WRITTEN REPRESENTATION FOR SPR EA1N and EA2 PROJECTS (DEADLINE 1)

SITE SELECTION

Interested Party: SASES **PINS Refs:** 20024106 & 20024110

Date: 2 November 2020

Figure 2. Surface Water Flood Risk to SPR selection zones (except Broom Covert)

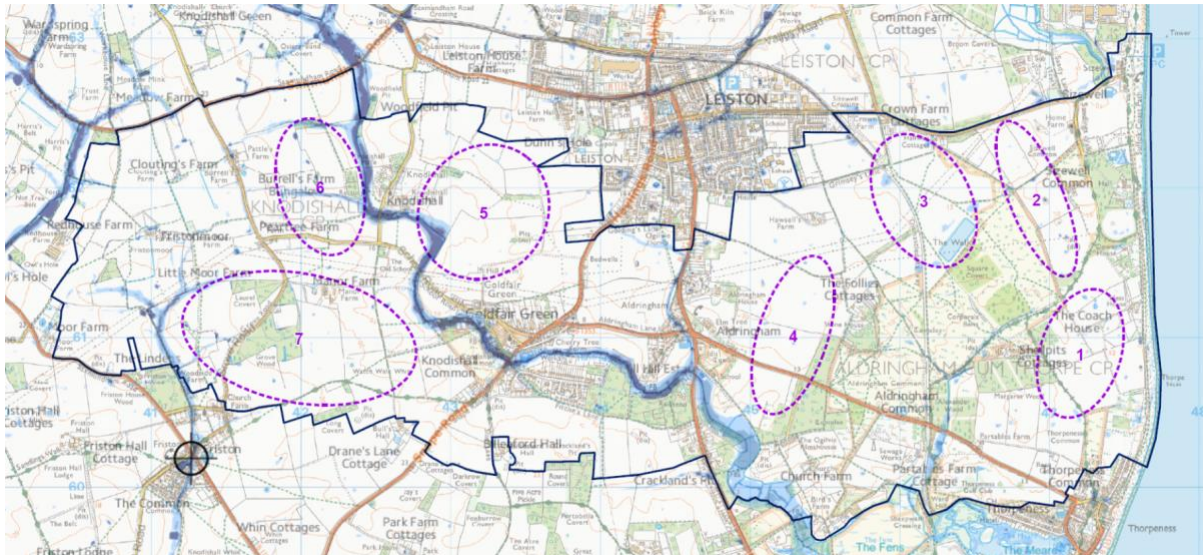
- Given this clear flood risk to the NGET substation area and adjoining land required for NGET realignment and other works as part of the linked NSIP, the applicant's obligations under the NPPF (as confirmed by NPS EN-1, EN-3 and EN-5) are understood to require the Sequential Test for flood risk to be undertaken, whereby the Grove Wood site is compared with other relevant sites also in Fluvial Flood Zone 1. There is no evidence that this has been done. Indeed it is not clear how the Grove Wood NGET site could pass such a test given that sites adjacent to the overhead lines in the other zones considered by SPR as part of their Site Selection process can be seen as not having a surface water flood risk (Figure 2 below). (Note that Zone 7 is also referred to as 'W1').

- It is clear, therefore, that SPR now accept that the National Grid site area **is** subject a serious surface water flood risk and in that case a **Flood Risk Sequential Test** would have been expected as part of the overall Site Selection and DCO Application processes. But no documented evidence has been found that this test has been carried out across the various sites available (see Figure 2 and Broom Covert), or that the test has been approved by the relevant Local Authority (ESDC and/or SCC). The selection of Grove Wood as the site for EA1N, EA2 and NGET substations and associated overhead line works must therefore be unsound.
